REVISION [État]: THIS WARRANTY BULLETIN SUPERSEDES PREVIOUS VERSION.
First release

MCM SERVICE SWITCH FUNCTIONALITY- CORRECTIVE MEASURE ON I-START EQUIPPED VEHICLES 9700 (B13R)

On the vehicles affected by this bulletin, a fix is required to allow normal functionality of the MCM switch.

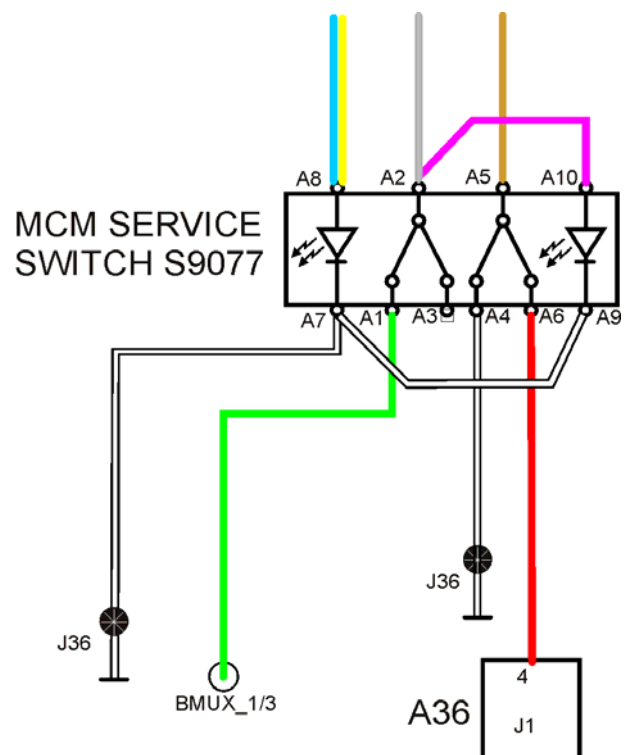
- 4) Disconnect the **purple wire** at cavity **A1**
- 5) Disconnect the **gray wire** at cavity **A2** and cut off end terminal. Double crimp **gray wire** with the **purple wire from A10** using terminal #970745 and then connect to cavity **A2**.
- 6) Cut the **white wire** routed between A9 and MCM module (A36) at about 6 inches from S9077.
- 7) Seal off the white wire end routed to MCM (A36) or remove this wire completely.
- 8) Disconnect the **white wire** at cavity **A7** and cut off end terminal. Double crimp the **white wire** with the **white wire from A9** using terminal #970745 and then connect to cavity **A7**.

Before

After

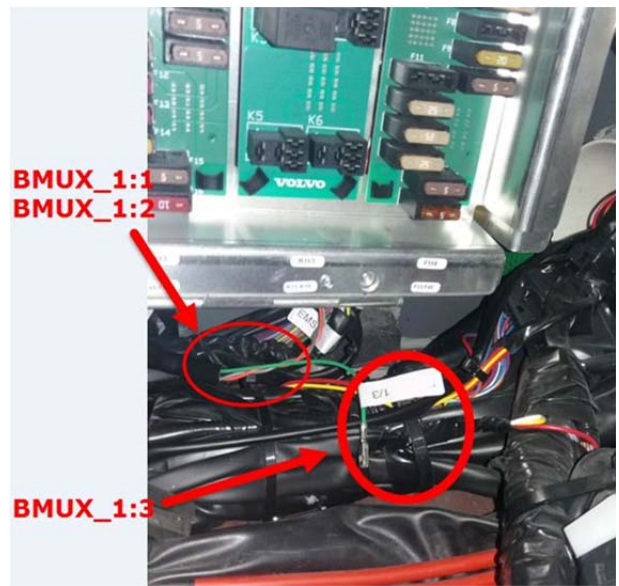
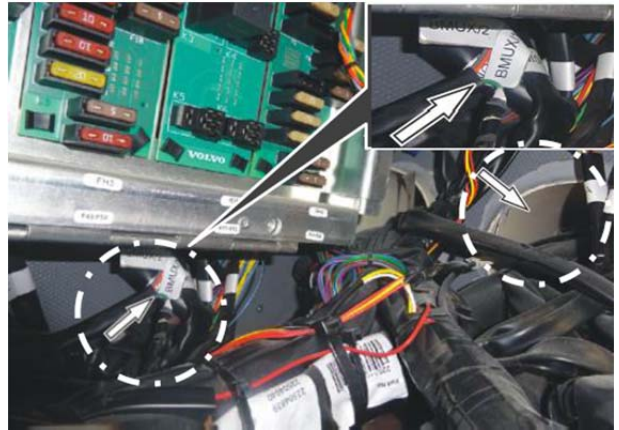
- 9) Locate the following wires and PVC pipe:
BMUX_1/1 (Grey),
BMUX_1/2 (Orange),
BMUX_1/3 (Green) wires.

NOTE: (orange & grey wires are twisted together)

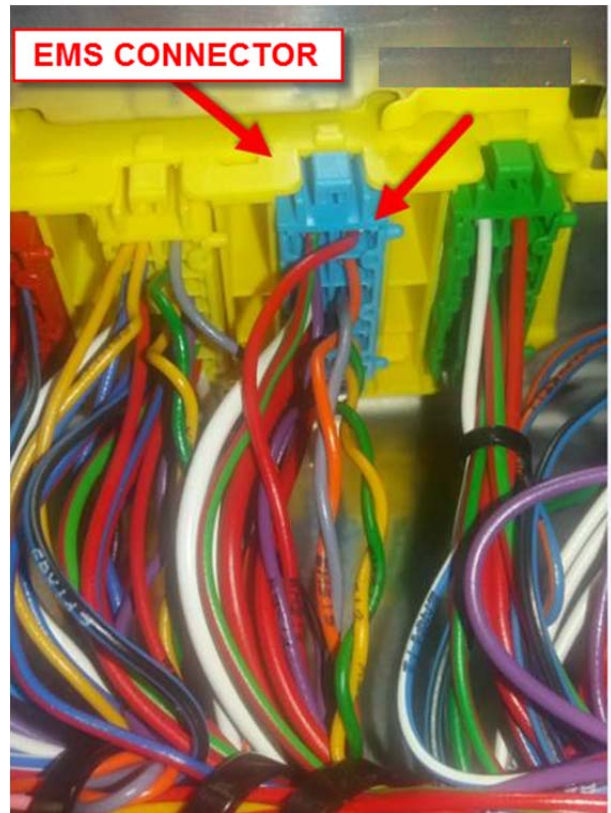
- 10) Disconnect BMUX/1 and BMUX/2 (orange & grey wires twisted together) wires from EMS connector.

- 11) Extend BMUX/1, BMUX/2, BMUX_1/3 using splice #956956 and corresponding color coded wire. IMPORTANT: Read the note below.

Note: BMUX/1 & BMUX/2 (orange & grey wires) must be twisted together: twist pitch 9.2 turns/ft (30 turns/meter), that makes 75 turns for 98" long wire.

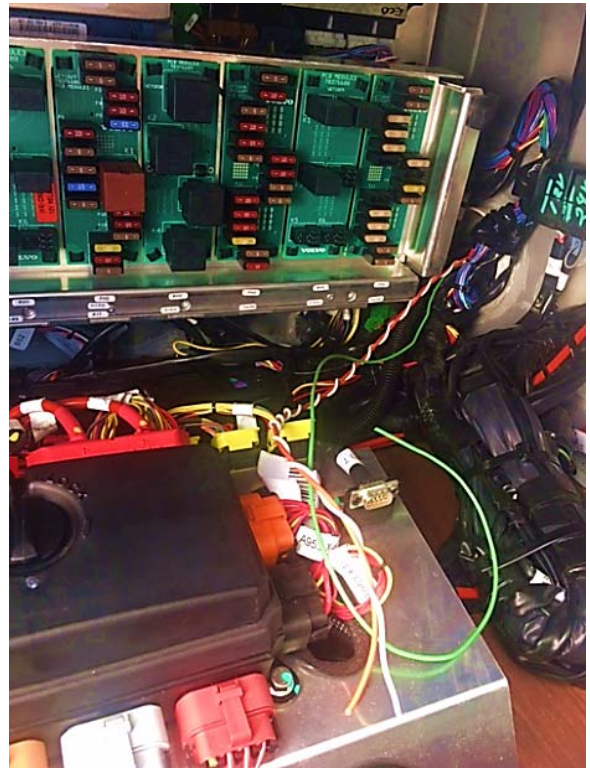
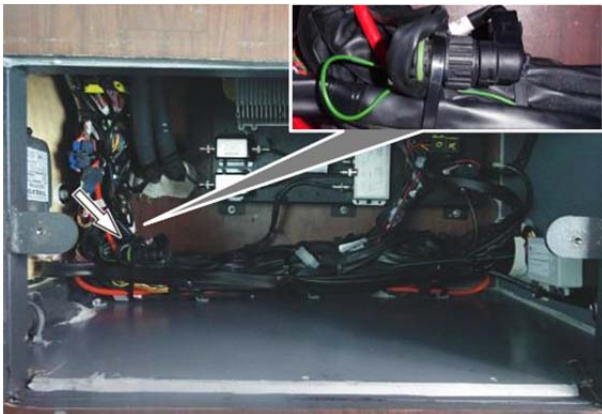
- 12) Open the service hatch behind driver seat.
- 13) Install BMUX connector (**#25371156**). Route wires in PVC pipe in order to reach BMUX connector.
